**Case #:** PB 2016-14-R1 (11/2017)  
**Date:** January 30, 2018  
**Recommendation:** Conditional Approval

**PLANNING STAFF REPORT**

**Site:** Assembly Line Park – Building B

Legal Notice: Applicant & Owner, Street Retail, Inc., seek a revision to Special Permit with Site Plan Review–A, final level approval (Decision dated September 22, 2016) of the food service or retail buildings located within Assembly Line Park to add decorative screening to cover mechanical louvers on the east elevation of Building B.

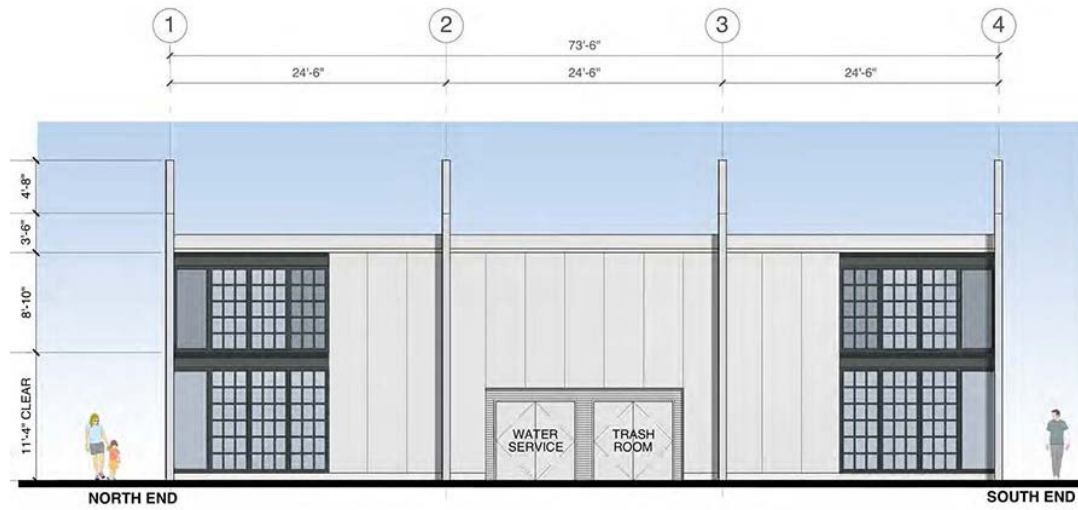
This request is to gain approval for decorative screen to cover mechanical louvers that were added during construction and changes the building from the approved elevation.

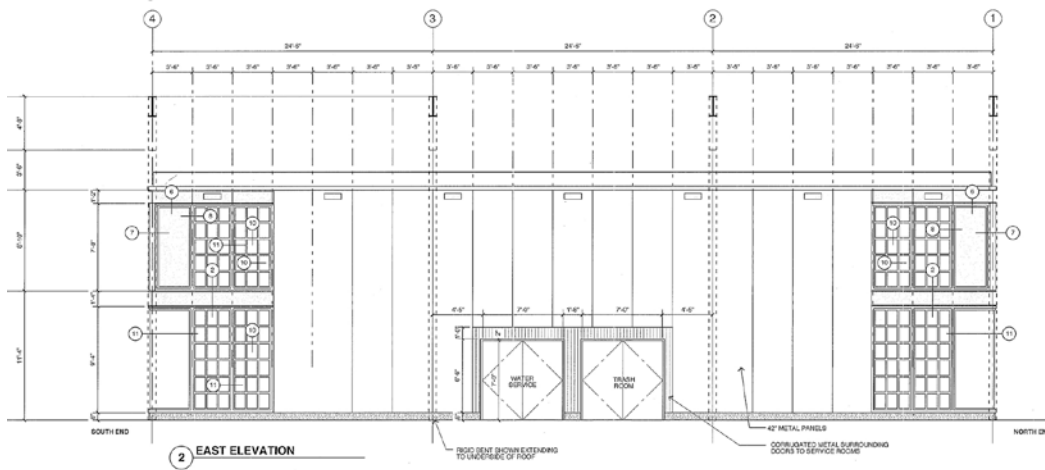
The original approved elevation is shown below. This elevation shows no louvers and four bays of fenestration at each end of the building.

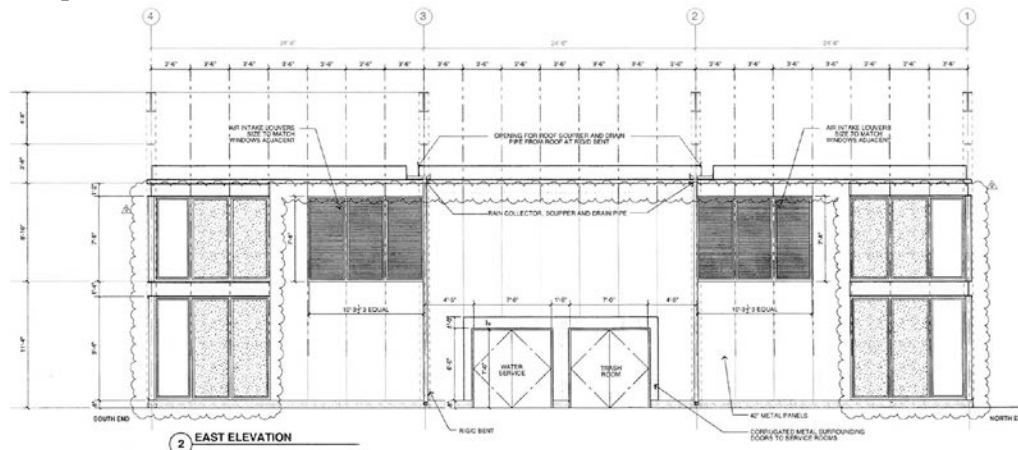
The elevation from the building permit application (shown below) shows reduced fenestration at the north and south ends of the building - three bays instead of four but still showing windows.

The as-built condition provided with this application (below) shows the extent of the changes that were made during construction without prior Staff or Planning Board approval. Note the mechanical louvers and the blank panels instead of windows.

The design change became evident upon final review by Planning Staff and Inspectional Services when the Applicant applied for a Certificate of Occupancy. The three bays of panels are acceptable, but the exposed mechanical louvers create a “rear” appearance to the building that was intended to be a four-sided pavilion. The decorative louvers proposed are an acceptable approach to visually screening the necessary but unsightly louvers.

The Applicant will submit final detailed drawings along with material and color samples for the decorative screens/art installations, covering the mechanical louvers on the west elevation of Assembly Line Park Building B, prior to fabrication of those screens to Planning Staff for review and approval.
